SERVICE BULLETIN

No. SB-AG-71

S2R-T34 MVP & GCU WIRING RELOCATION

Figure 2
Original Schematic

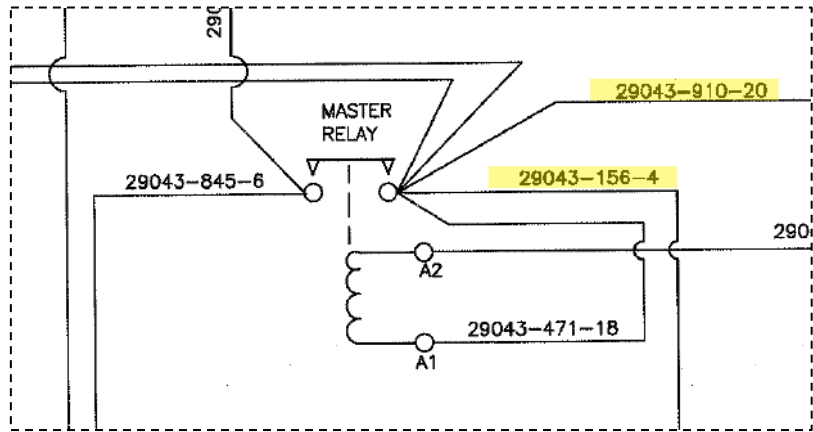
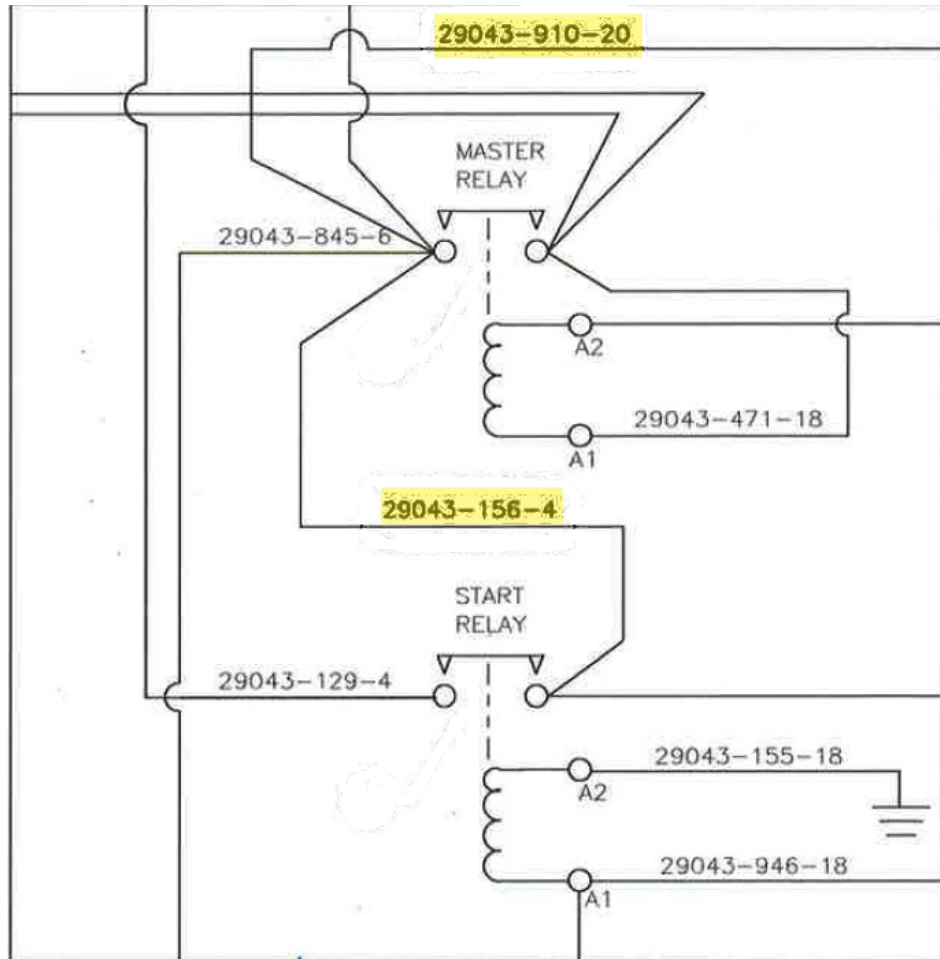
- 3) Remove wires 29043-156-4 & 29043-910-20 from the B stud of the Master Relay located at the battery plate. See Figures 2 and 3.

- 4) Reroute wires 29043-156-4 & 29043-910-20 to the A stud of the Master Relay. See Figure 3 and 4.
- 5) Reuse hardware and be aware not to deform the terminal lugs or the studs while installing.
